**Work Order ID 70909**

Item Name: Gusset

DRAWING NO. D3016	TITLE SEAT FRAME ASSEMBLY	REV. A	DART AEROSPACE LTD ENGINEERING ORDER		D.E.O. NO. D3016-A-1	SHEET NO. SHEET 1 OF 1	SCALE NTS
DRAWN	CHECKED	MFG. APPR.	APPROVED	DE APPR.			
DATE 10.01.29	DATE 10.01.29	DATE 10.01.29	DATE 10.01.29	DATE 10.01.29	DATE 10.01.29

TO REVISE D3016-11 SADDLE'S HOLE SIZES

**D3016-11 SADDLE**

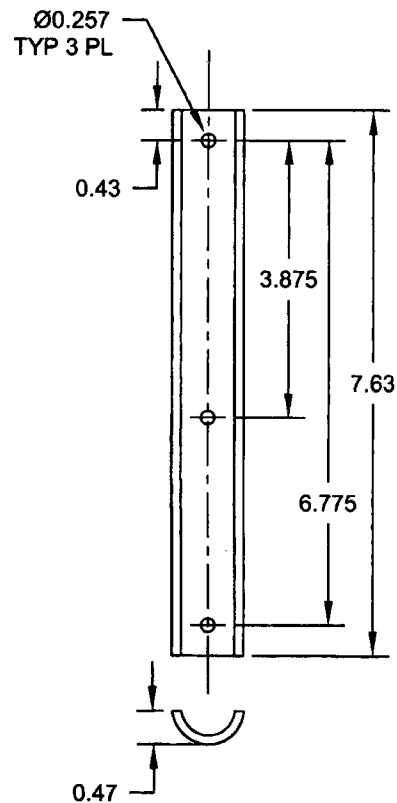
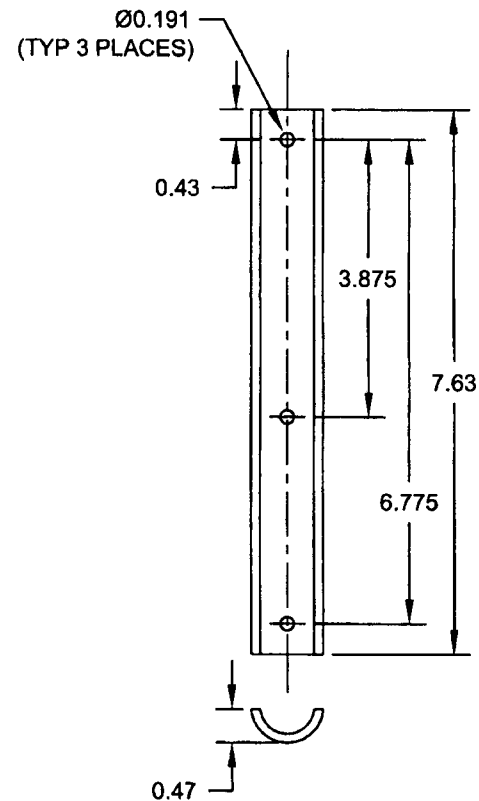
DETAIL D3016-11 SADDLE (SHEET 3): Ø0.257 TYP 3 PL WAS Ø0.191 (TYP 3 PLACES) AS SHOWN:
